Access Compliance Report

Public Rights-of-Way

(Curb Ramps)

| Intersection ID: 52590 | Main Street: NOBLES_AV | Cross Street: TRIUMPH_DR | Location: SW |

| ADA ID: 133234A7532A | Ramp Type: Perp | Initial Pass/Fail: Fail | Overall Compliance: No |

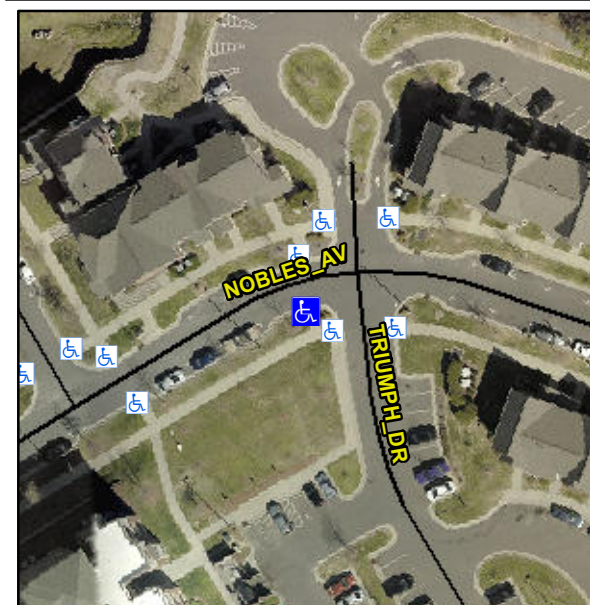
Remove & Replace Entire Ramp.

Not Found, R304.5.3

| Compliance | Description | Data | Compliance | Description | Data |
|------------|-----------------------|------|------------|-----------------------------|------|
| Yes | Ramp Width (in) | 70.0 | No | Ramp XSlope (%) | 6.3 |
